YUCCA MOUNTAIN - REQUEST FOR ADDITIONAL INFORMATION - SAFETY  
EVALUATION REPORT, VOLUME 3 - POSTCLOSURE CHAPTER 2.2.1.3.2,  
MECHANICAL DISRUPTION OF ENGINEERED BARRIERS, 3RD SET - (DEPARTMENT  
OF ENERGY'S SAFETY ANALYSIS REPORT SECTION 2.3.4)

Response to RAI Volume 3, Chapter 2.2.1.3.2, Set 3, Number 1

**RAI Volume 3, Chapter 2.2.1.3.2, Third Set, Number 1:**

Figure 1. Components of the Interlocking Drip Shield

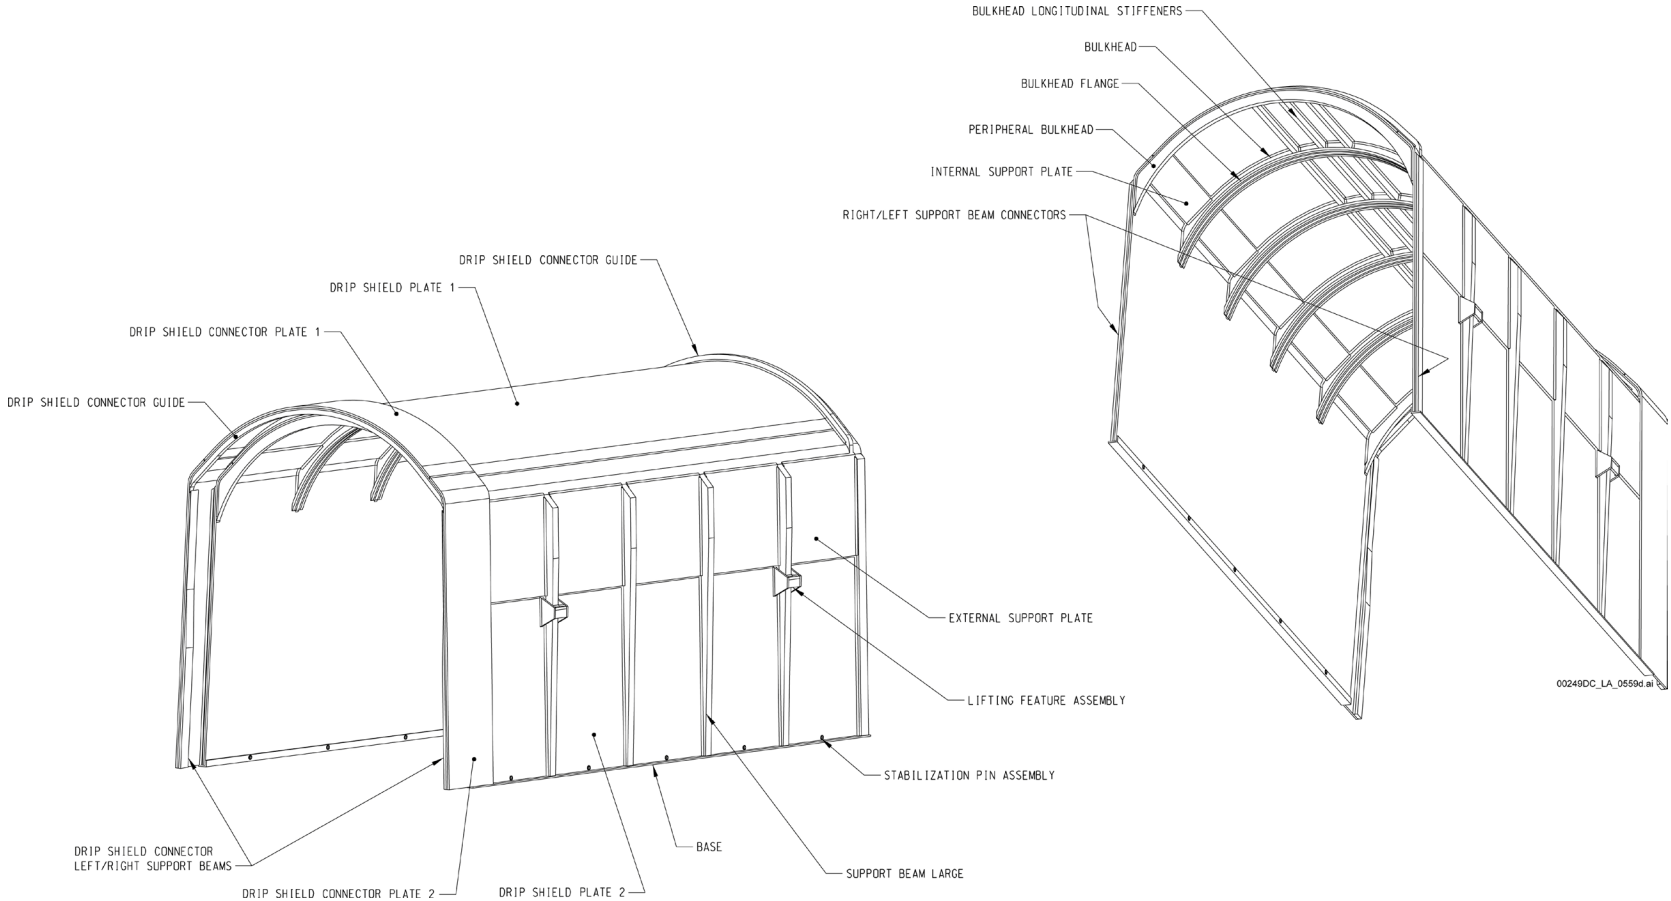
Demonstrate that the drip shield retains adequate seepage barrier functionality after deformation (SAR 2.3.4.5.3).

As shown in Figure 1, the drip shield consists of a framework of bulkheads and beams that support the plates, which are welded to the framework. Five bulkheads and one peripheral bulkhead divide the crown of the drip shield into five sections (or segments). The sidewalls of the drip shield are also divided into five sections by the four large support beams, a support beam connector, and the drip shield connector plate. As used in this response, the term “sidewalls” or “legs” refers to Plate-2 (see Figure 1), the large support beams on Plate-2, and the external support plates welded to Plate-2. Each of the five sections has similar components and similar mechanical stiffness, a fact that has been used to simplify the three-dimensional structural response calculations for the drip shield.

The crown of the drip shield is highly reinforced by the design shown in Figure 1. For example, the five bulkheads supporting the crown plate (Plate-1 in Figure 1) are 902.8 mm high and 38.1 mm thick. Each bulkhead also has a bottom flange that is 20 mm thick. These bulkheads and flanges provide a stiff framework under vertical and lateral (i.e., perpendicular to the drift axis) loading.

Figure 4. Comparison of Ultimate Plastic Load Capacity (limit load) for the Drip Shield Framework and Drip Shield Crown Plates

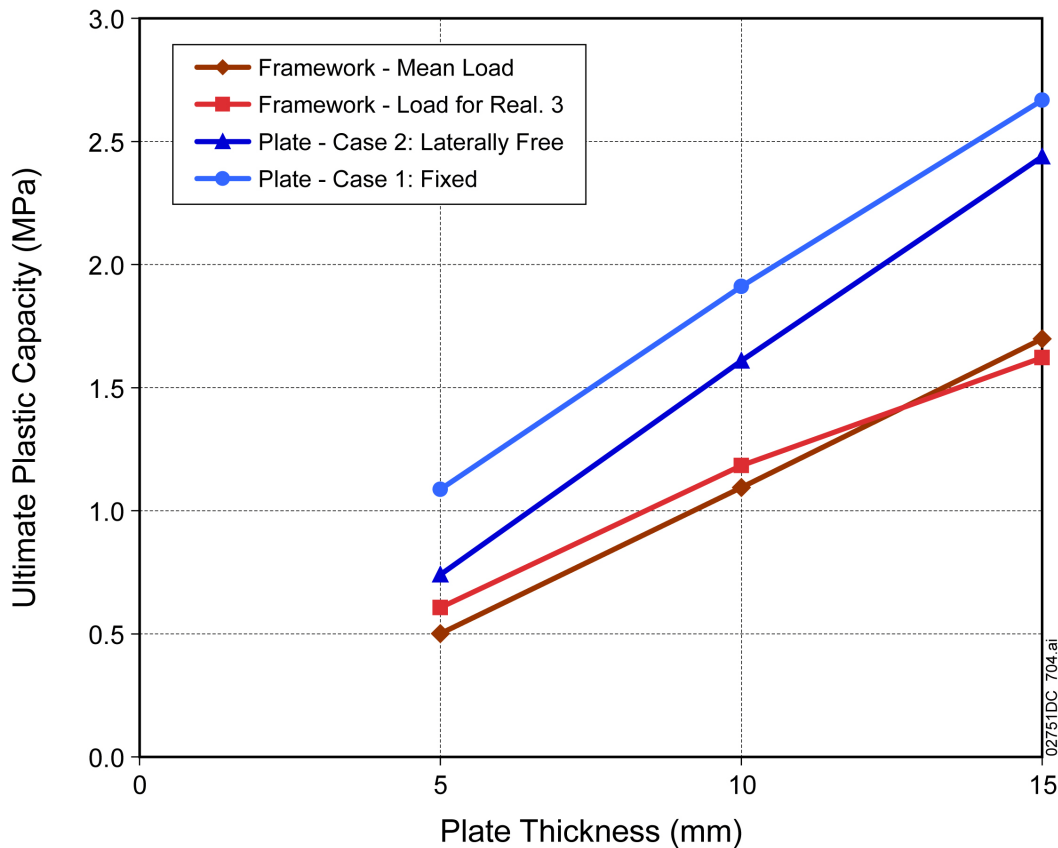
Analyses also show that for an intact drip shield framework (i.e., no uniform corrosion), the bulkhead snaps through in the middle of the crown span during failure (SAR, 2.3.4.5.3.3.2). The SAR does not explain the apparent inconsistency between the analyses used to generate the drip shield abstractions for the first tens of thousands of years, and the conclusion that the crown plates are structurally more robust than the framework legs (SAR Sections 2.3.4.5, 2.3.4.5.3.3.2, and 2.3.4.4.4.1), particularly in the context of barrier functionality.

The three-dimensional quasi-static calculations for the ultimate plastic load capacities of the drip shield framework and of the crown plates demonstrate that the crown plates are structurally more robust than the framework legs, as stated in SAR Section 2.3.4.5.3.2.3. Figure 4 provides a side-by-side comparison of the plastic load capacities, also called limit loads in the SAR, from the information in SAR Figures 2.3.4-81 and 2.3.4-83. The comparison in Figure 4 demonstrates that the plastic load capacities of the crown plates are always greater than the plastic load capacities of the framework for the three levels of corrosion thinning, providing the basis for the statement that the crown plates are structurally more robust than the framework. In addition, the difference in load capacity is consistently represented in the fragility curves for the framework and crown plates because, for a given level of corrosion thinning, the probability of rupture of the crown plates is always lower than the probability of the sidewalls buckling at a given ground motion level (SAR Tables 2.3.4-43 and 2.3.4-44).

The three-dimensional quasi-static analyses also show that the failure mode for the as-installed drip shield is snap-through of the crown at the middle of its span (SAR Figure 2.3.4-82 and SAR Section 2.3.4.5.3.3.2). This failure mode is different than the failure mode for the two-dimensional dynamic calculations discussed in SAR Section 2.3.4.5.3.3.3. As explained in Section 1.2.1 of this response, the two-dimensional dynamic calculations typically fail by buckling of a sidewall near the bottom, approximately 20 to 30 cm from the contact with the invert, rather than by snap-through of the crown (SNL 2007a, Figure 6-60). Only one case in the dynamic two-dimensional calculations, ground-motion set number 11 at the 4.07 m/s PGV level, shows indications of failure in the crown. However, these potential crown failures occur at or near the shoulder, and do not exhibit a snap-through response (SAR Figure 2.3.4-85 and SNL 2007a, Section 6.4.4.6, Figures 6-60, 6-61, and 6-62). In this situation, any seepage through these crown failures would flow down the side of the drip shield and not cause advective releases from the waste packages.

Figure 5. Plastic Shear Strains in 15-mm-Thick Plate after 19.8-cm Differential Displacement

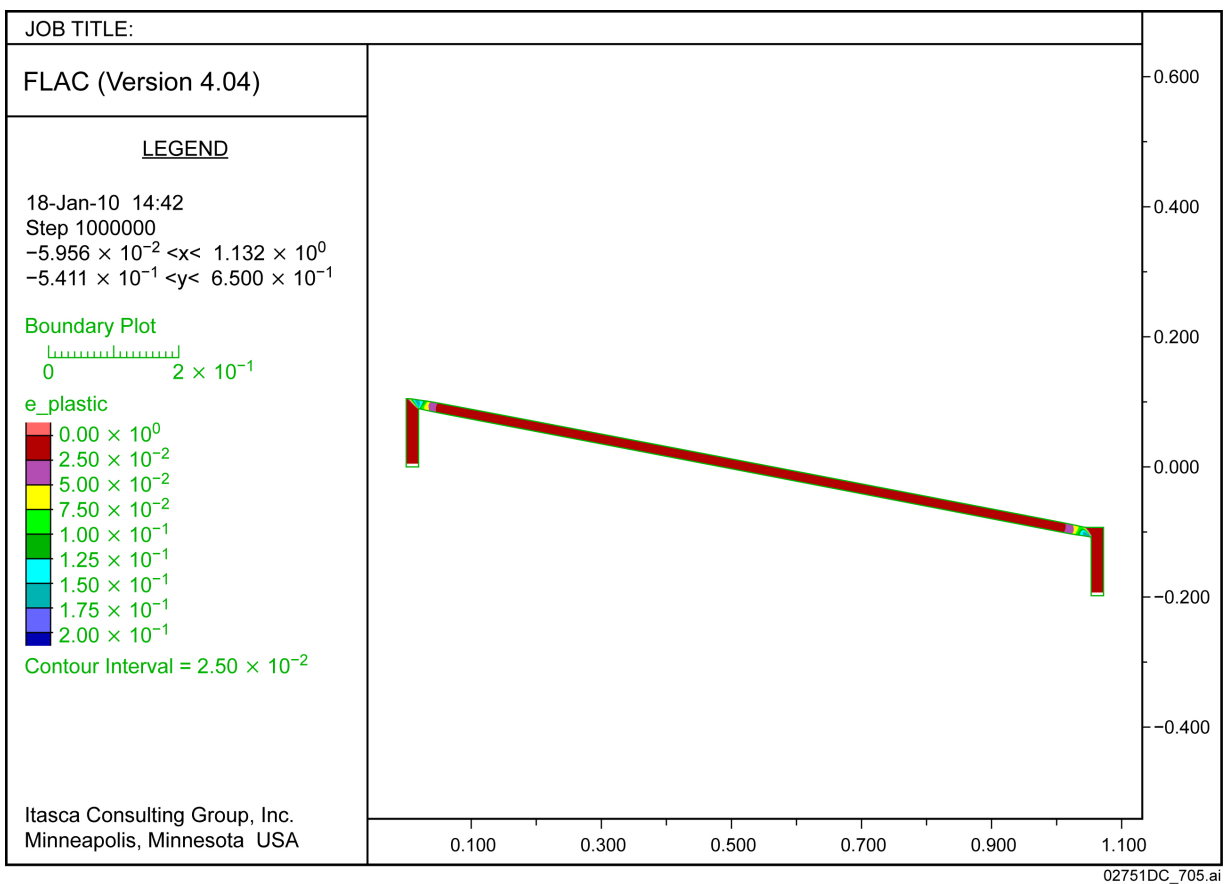
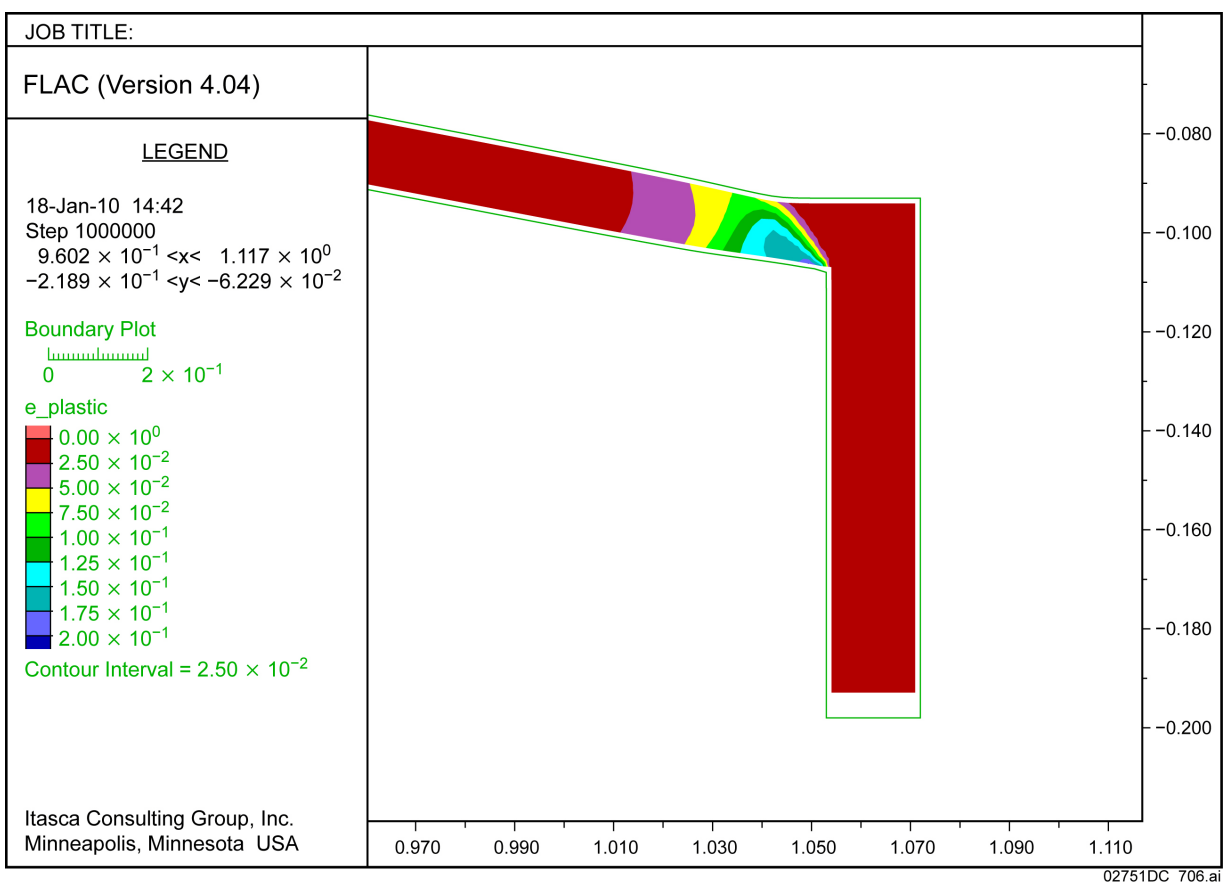
Basis: DOE concludes that the drip shield continues to function as a barrier to seepage after the drip shield framework collapses (SNL 2007ay; Section 6.12.2). SAR Section 2.3.4.5.3.3.2 concludes that the drip shield plates in the crown will remain intact after the framework legs buckle because they are structurally more robust than the framework. The SAR, however, does not discuss how an appropriate level of uncertainty for framework collapse (including spatial variability) has been considered. Neither does the SAR demonstrate that failures due to high stress concentrations in the collapsed Titanium Grade 7 plates are unlikely to occur or that seepage water inflow through deformed drip shields (e.g., discontinuities) will not affect performance significantly.

The contours of the plastic shear strain in a 15-mm-thick plate after 19.8-cm differential displacement are shown in Figures 5 and 6 (detail). This differential displacement corresponds to the point of rupture, when the maximum effective strain equals the ultimate strain. The plastic strains are localized at the contact between the plate and the bulkhead.
